SAN ANTONIO WATER SYSTEM
Dos Rios Water Recycling Center (DRWRC) Digester Mixing and System
Enhancements, Phase II
SAWS Job No. 11-6502
Solicitation No. B-12-053-MF

ADDENDUM NO. 4

EXHIBIT NO. 03M203-B

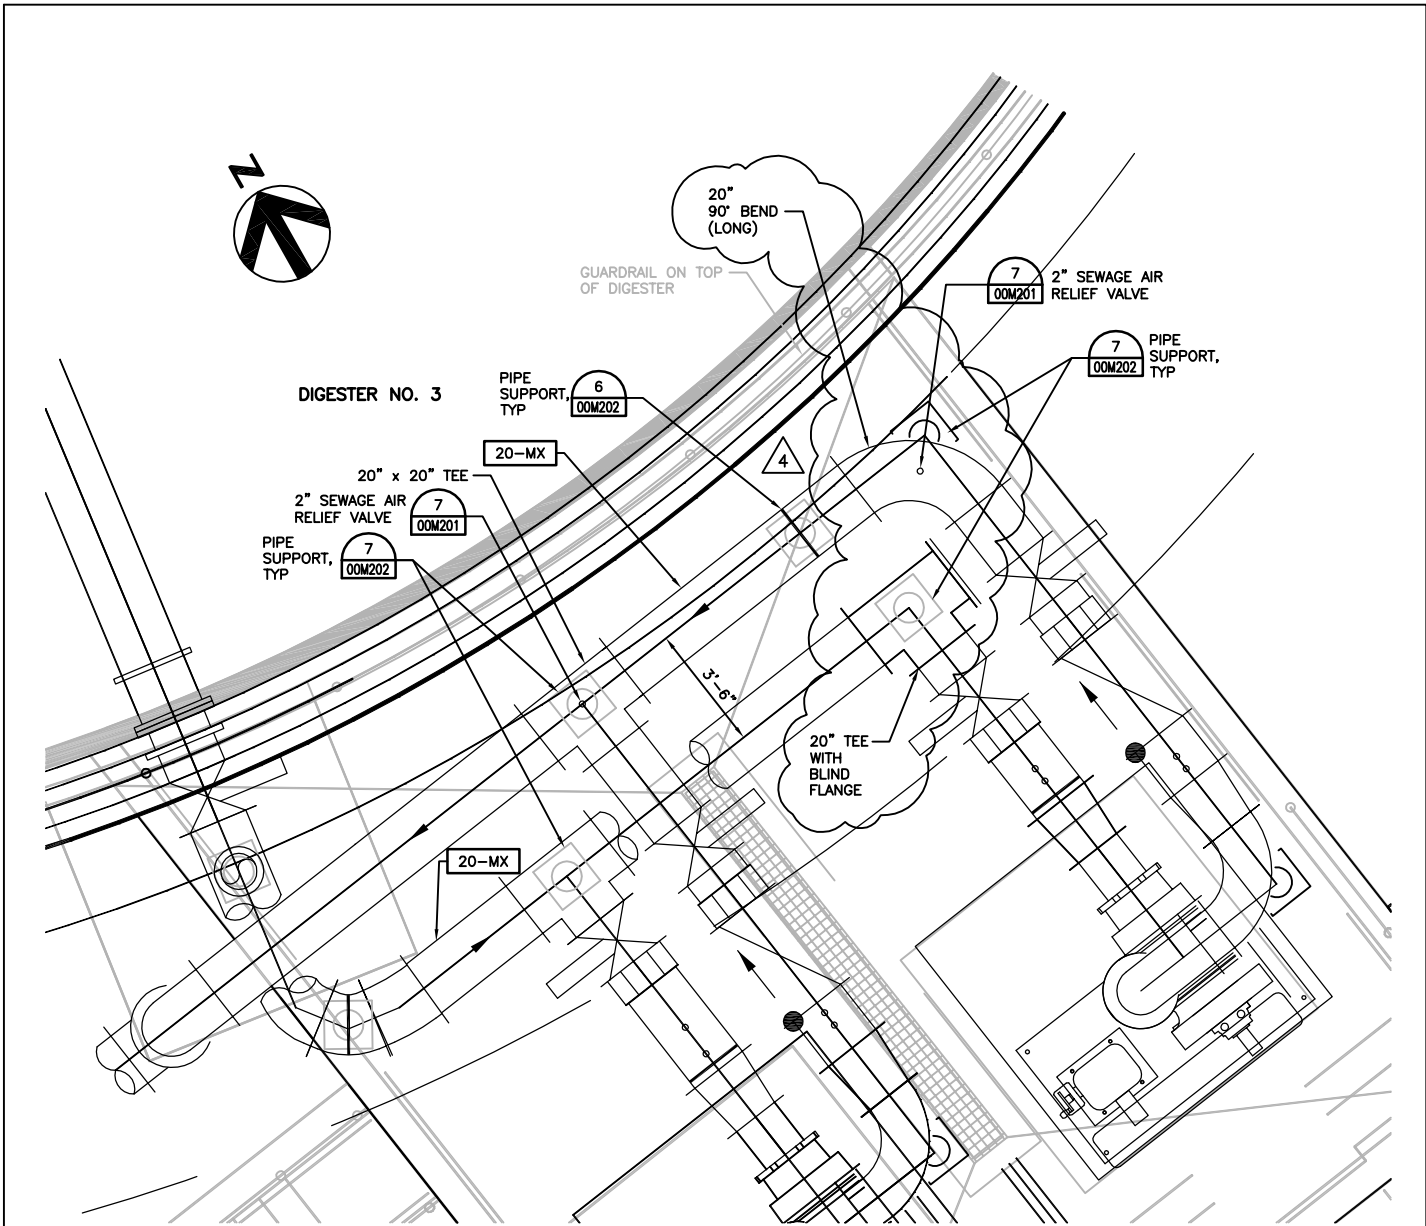
24. Drawing No. 03M203
 - a. For modifications to this drawing, refer to attached Exhibit 03M203-B.
25. Drawing No. 03M204
 - a. For modifications to this drawing, refer to attached Exhibit 03M204-A.

EXHIBIT NO. 04S101-A

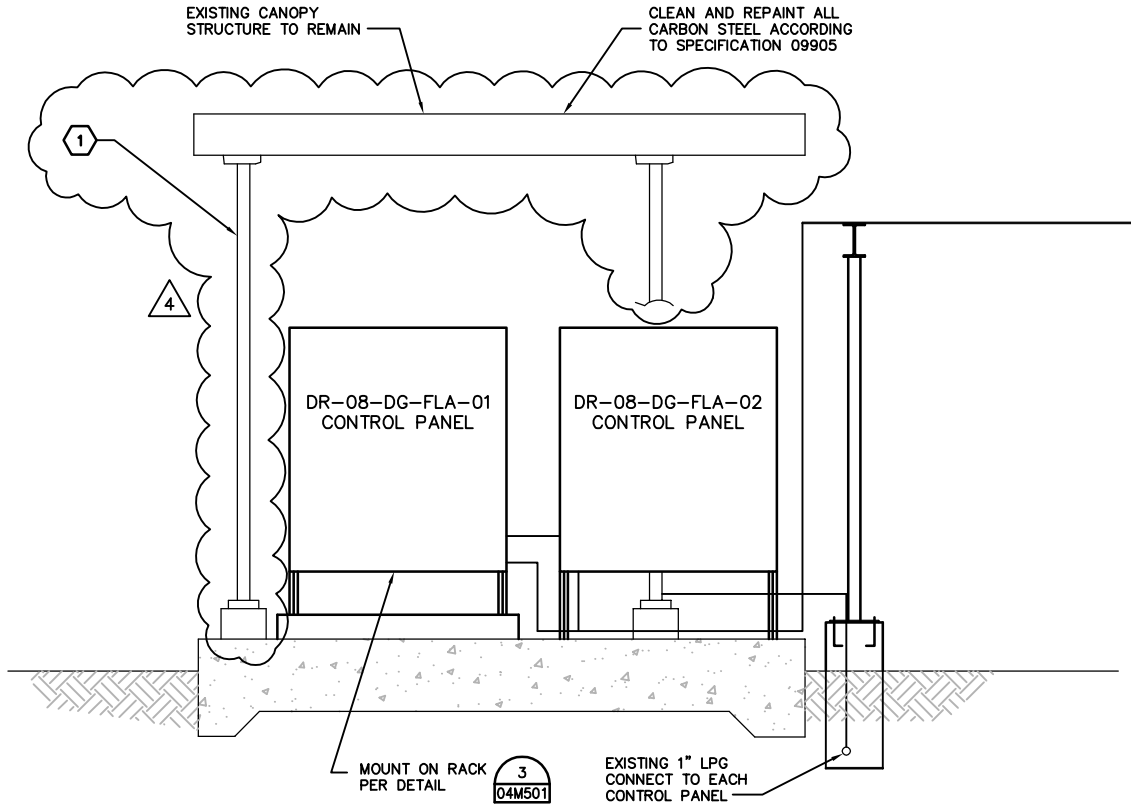
26. Drawing No. 04S101
 - a. Add photo to this drawing, refer to attached Exhibit 04S101-A.
27. Drawing No. 04M301
 - a. Add Section to this drawing, refer to attached Exhibit 04M301-A.
